# #SP23-054

**Project:** Les Schwab Tire Center – Parker, CO

**Date:** 4.17.2026

## Purpose of Change: Site Plan Adjustments

### E200 Detail Sheet

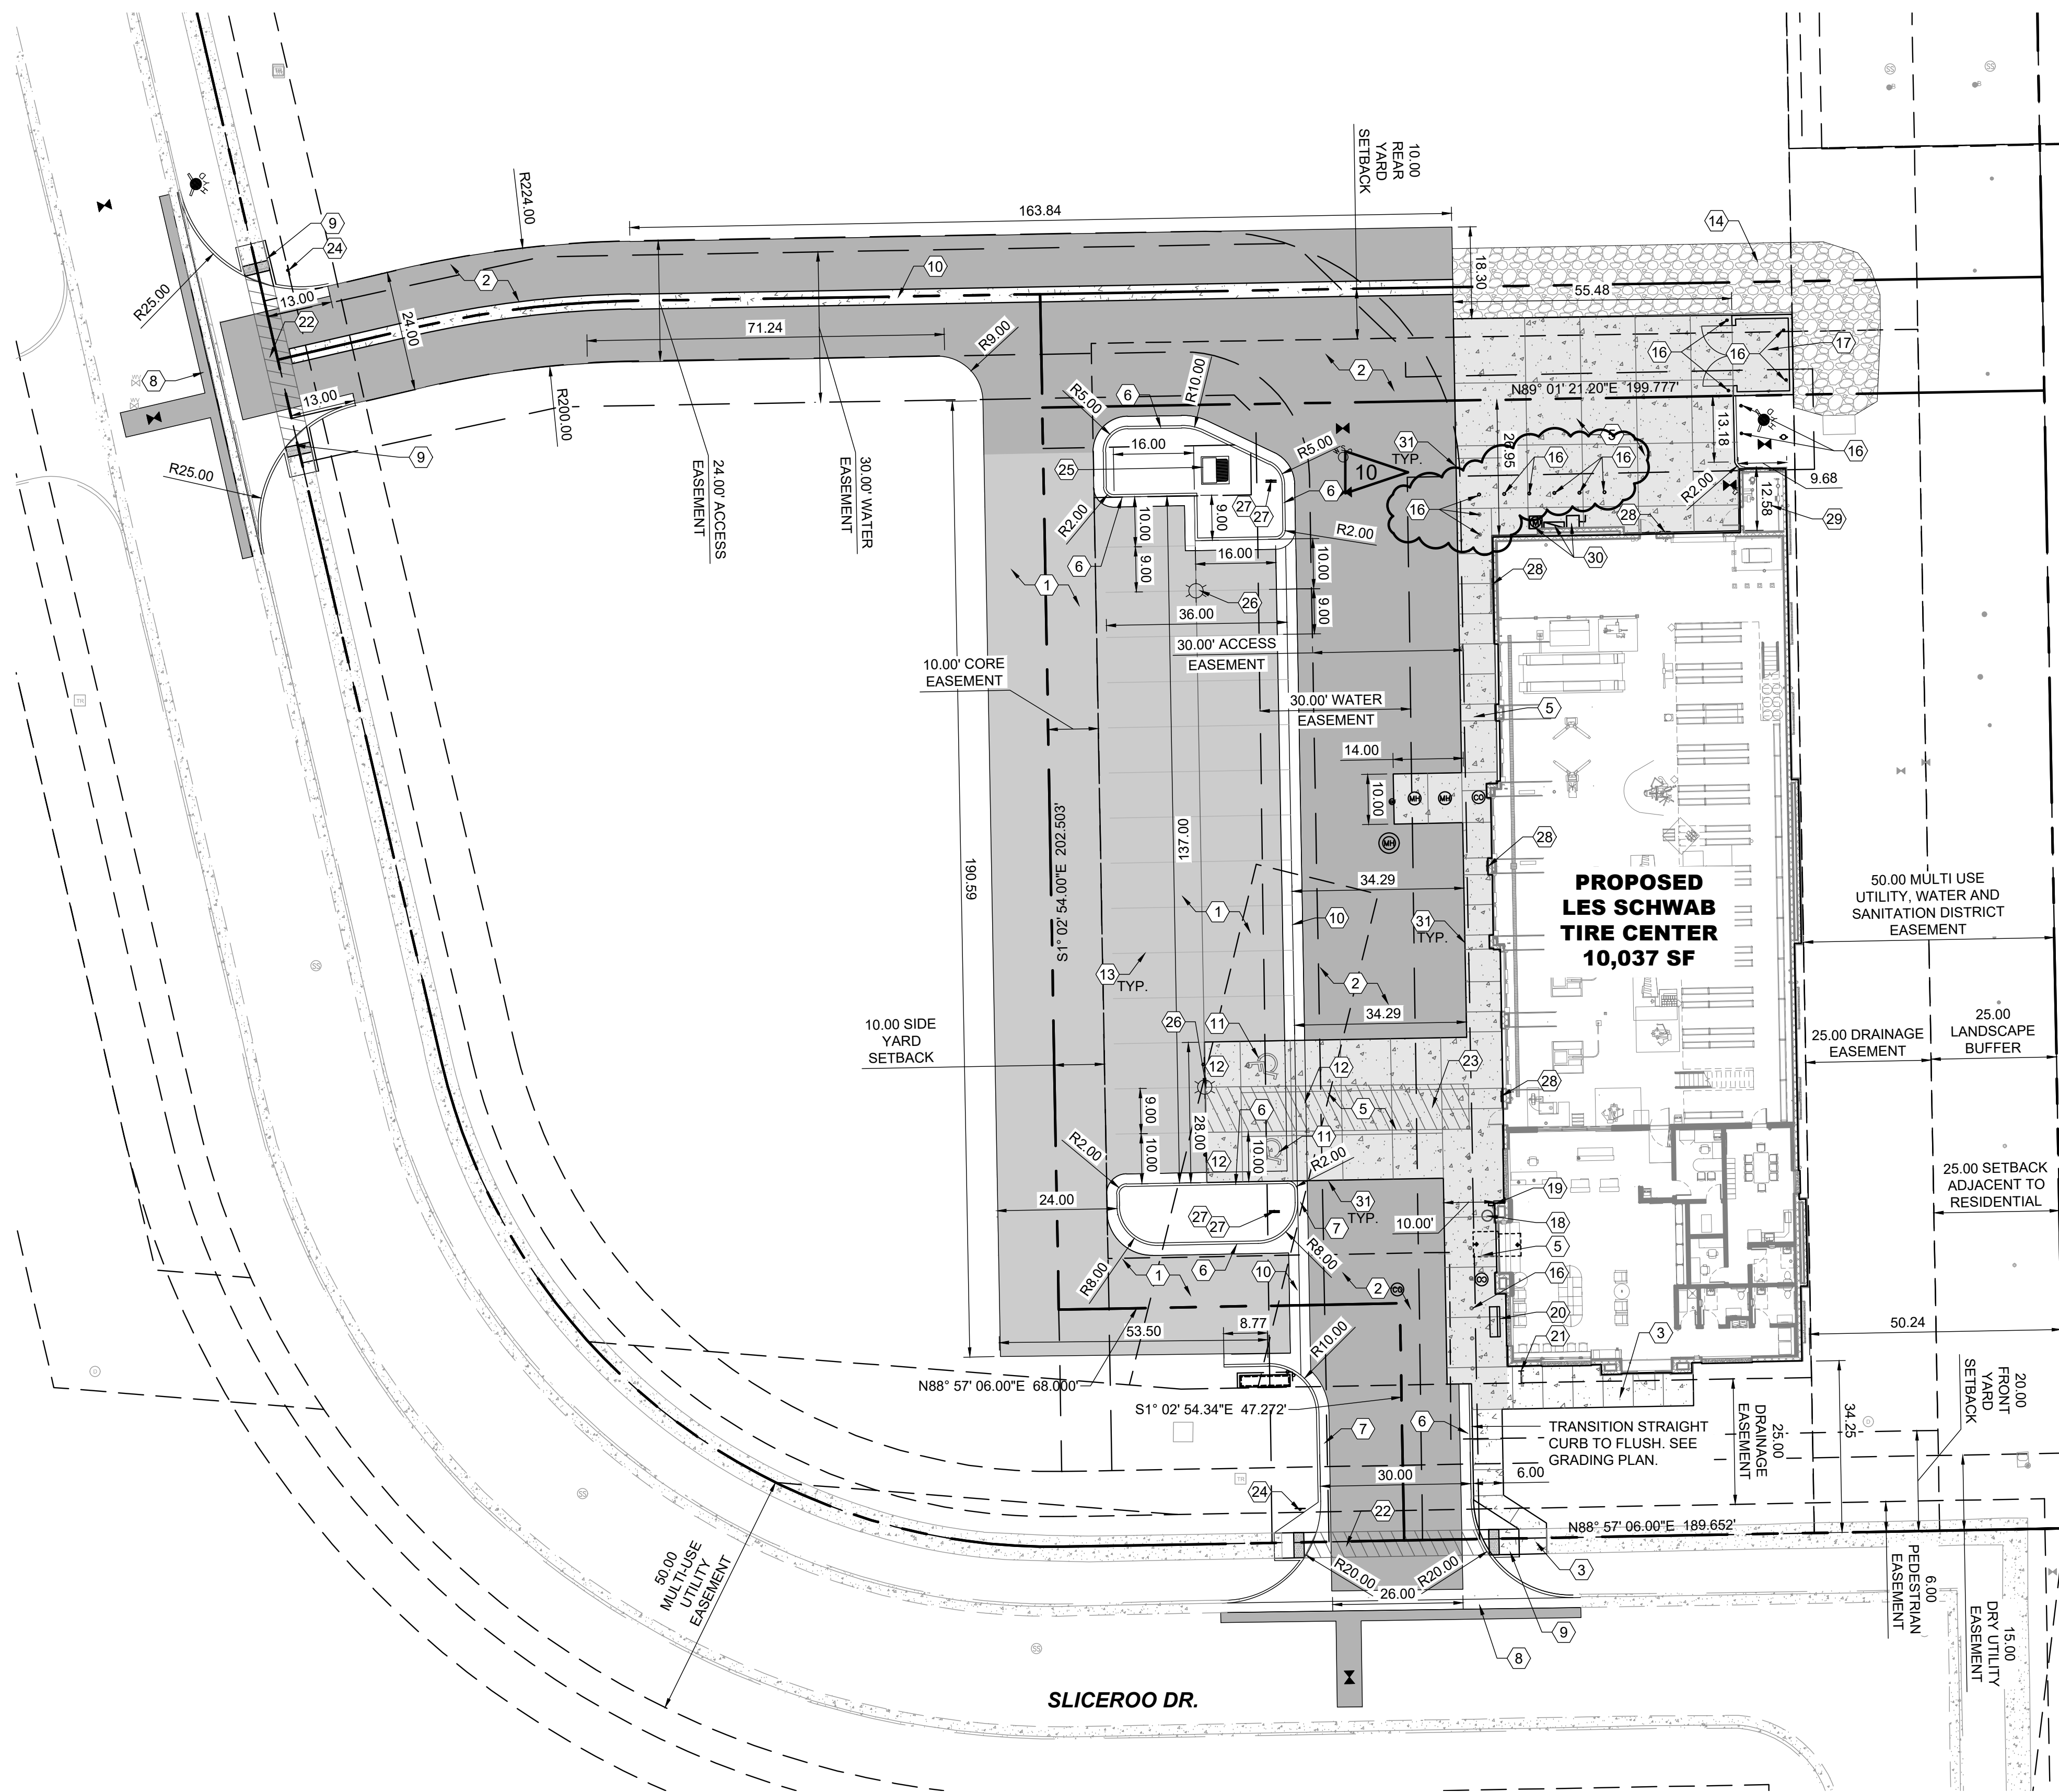
- 1. The initial site plan and cutsheet shows a double head. The cutsheet is for 1- 10 heads as shown below.

## SITE LIGHTING FIXTURE SCHEDULE

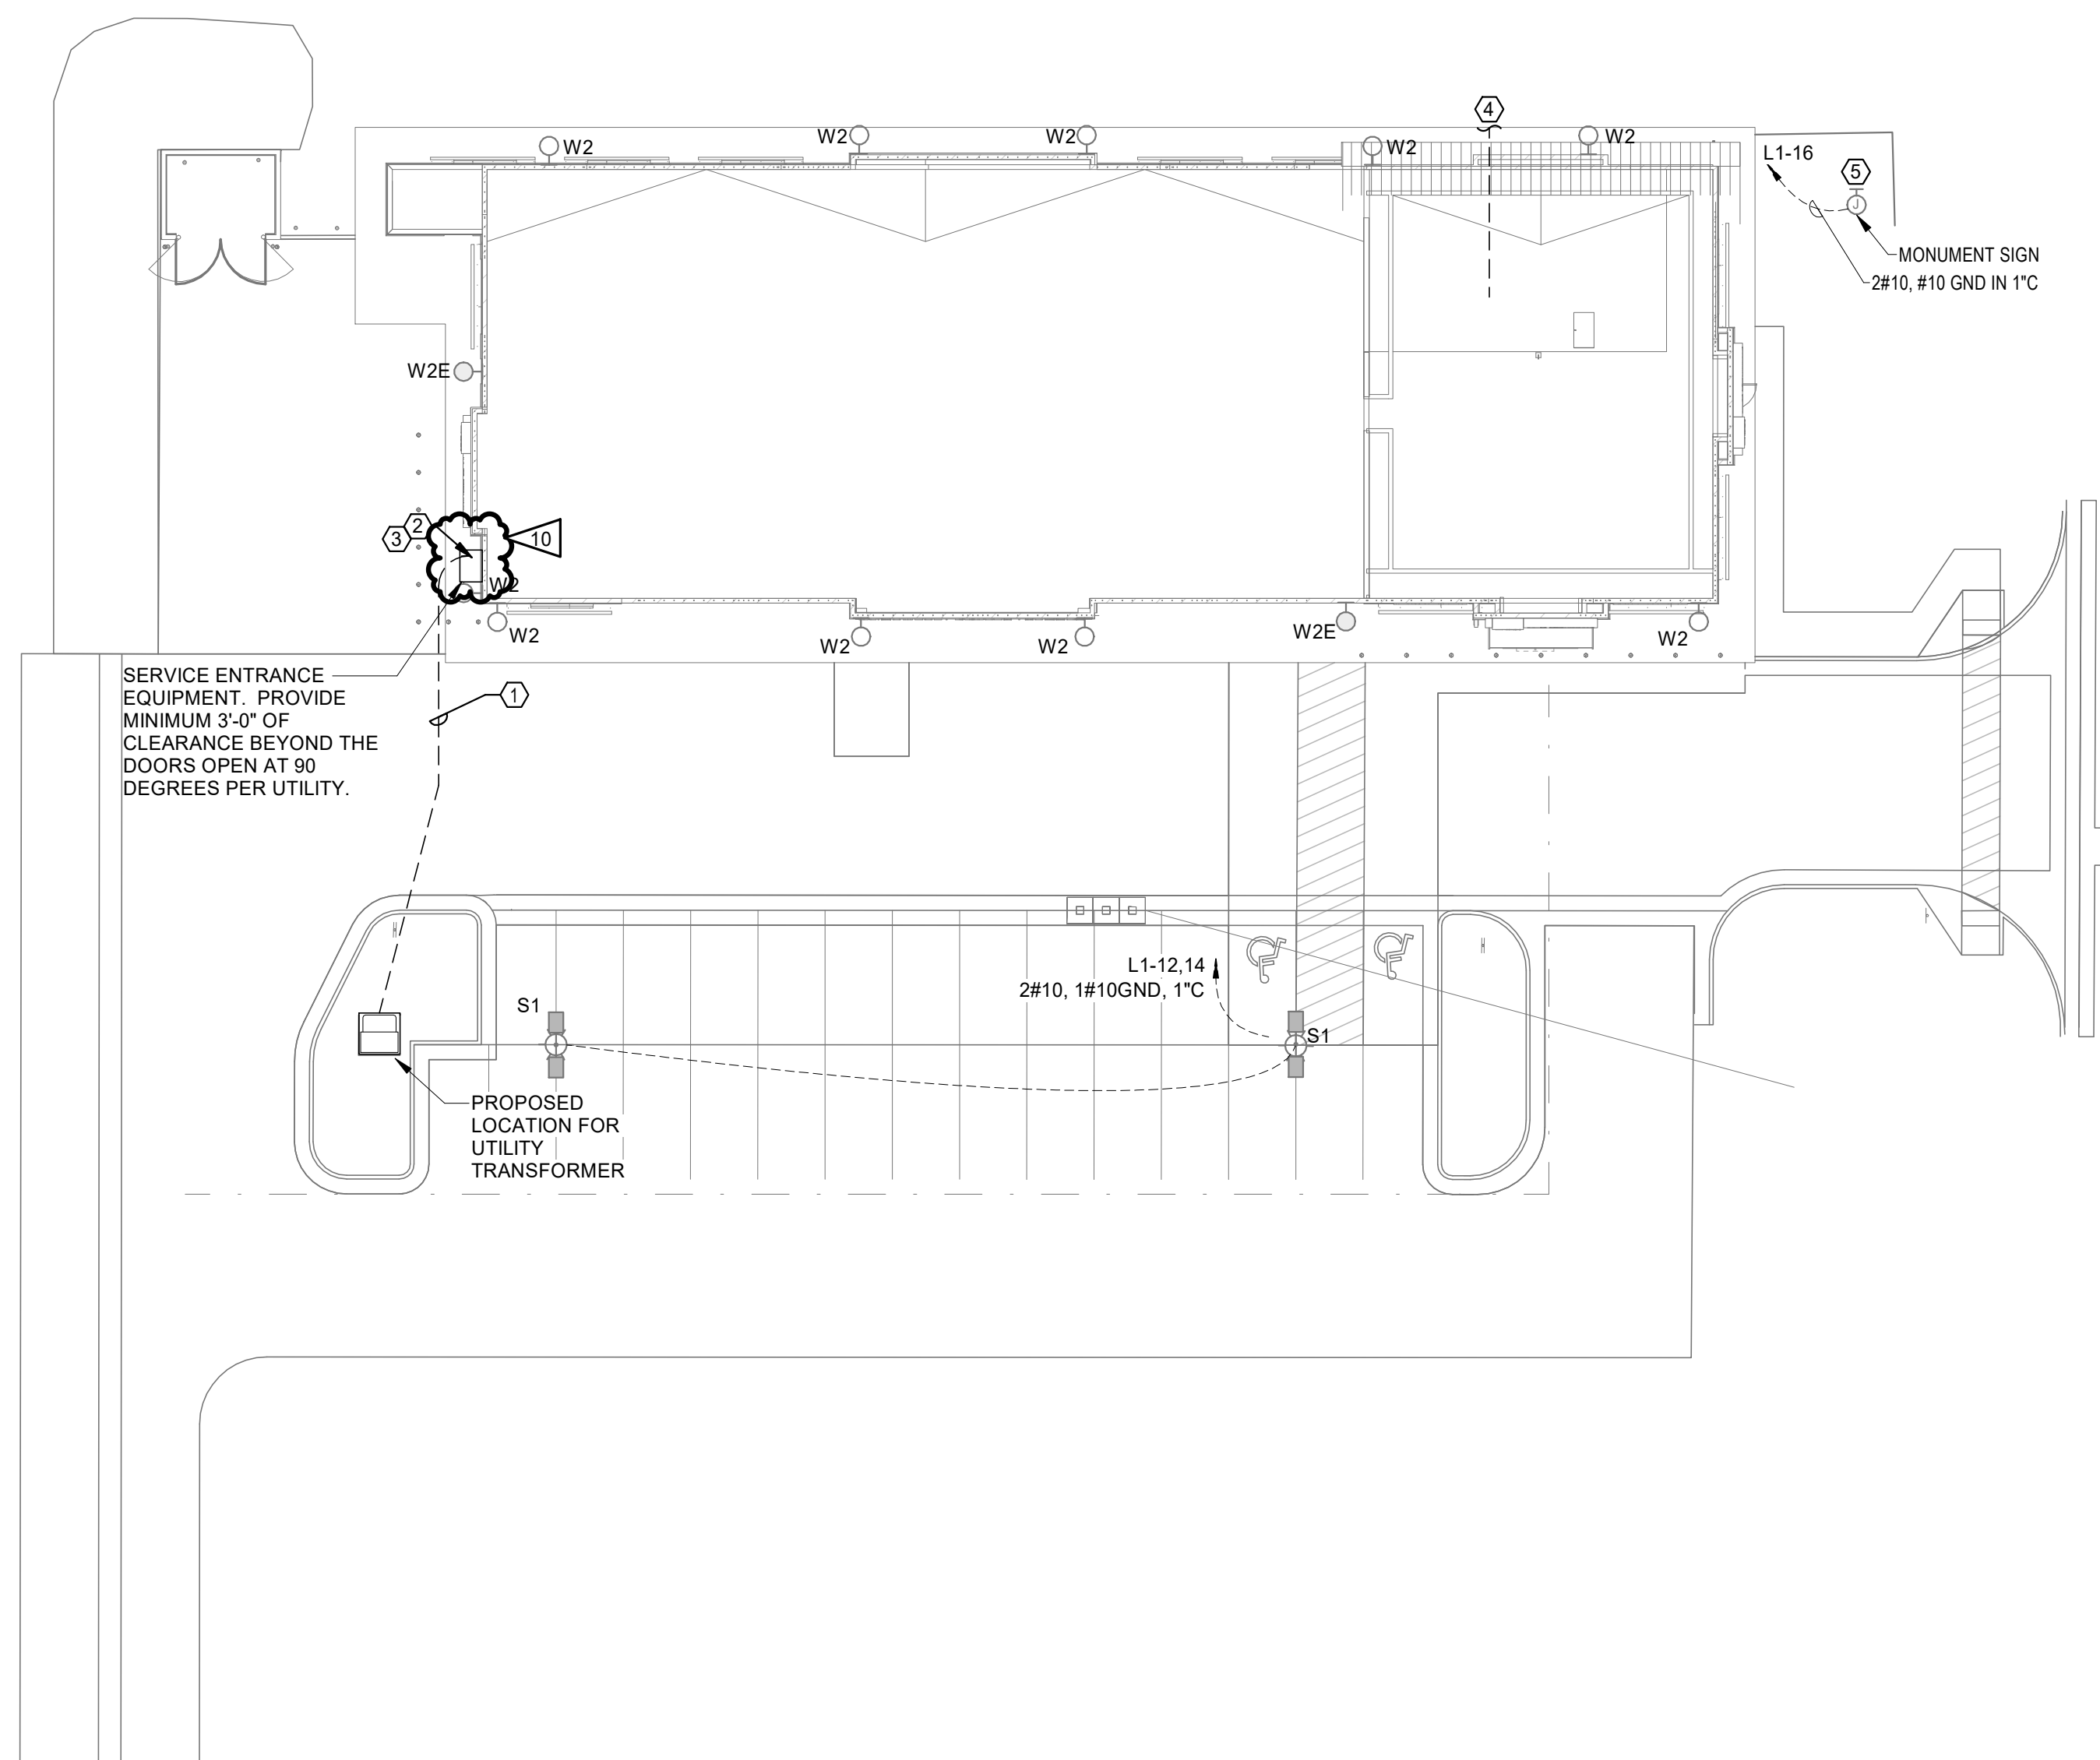
- 2. The wattage category on the entitlements photometric form has a 33/66 number in it for the S1 fixture. This means 33 watts per head for a total of 2 heads (66).
- 3. The South exterior is NOT considered a legal egress exit, therefore it does not require an exit light.
